Detroit
Edison

December 22, 1994
NRC-94-0132

Subject: Quality Assurance Program Change - Procedure Upgrade
Program

MARKED UP UFSAR
SECTION 17.2 PAGES

Administrative Hierarchy

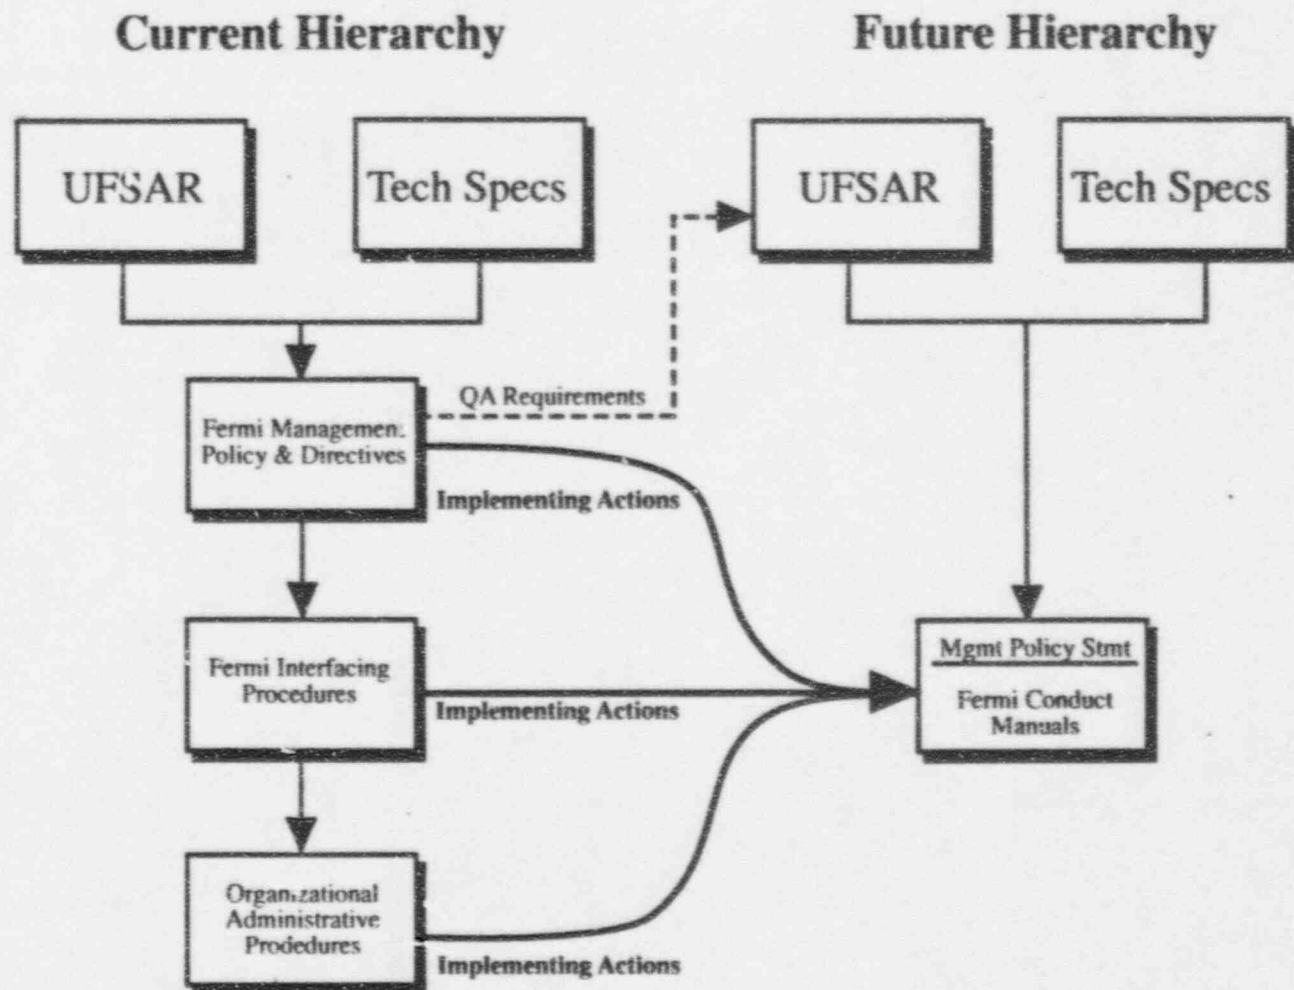
In the future, only Section 17.2 will be considered the Quality Assurance Program Description (QAPD) which meets the requirements of 10CFR50 Appendix B. This will be the only top tier document which describes QA Program requirements. Quality Assurance requirements and implementing actions previously described in the Fermi Management Policy & Directives Manual, Fermi Interfacing Procedures, and organizational administrative procedures will be consolidated and contained in the Fermi Conduct Manuals. The Conduct Manuals will be organized based on functional areas to make it easy for the worker to know where to go to obtain information. Management Policy statements will endorse the Conduct Manuals. The attached figure shows the current and planned hierarchy of administrative controls.
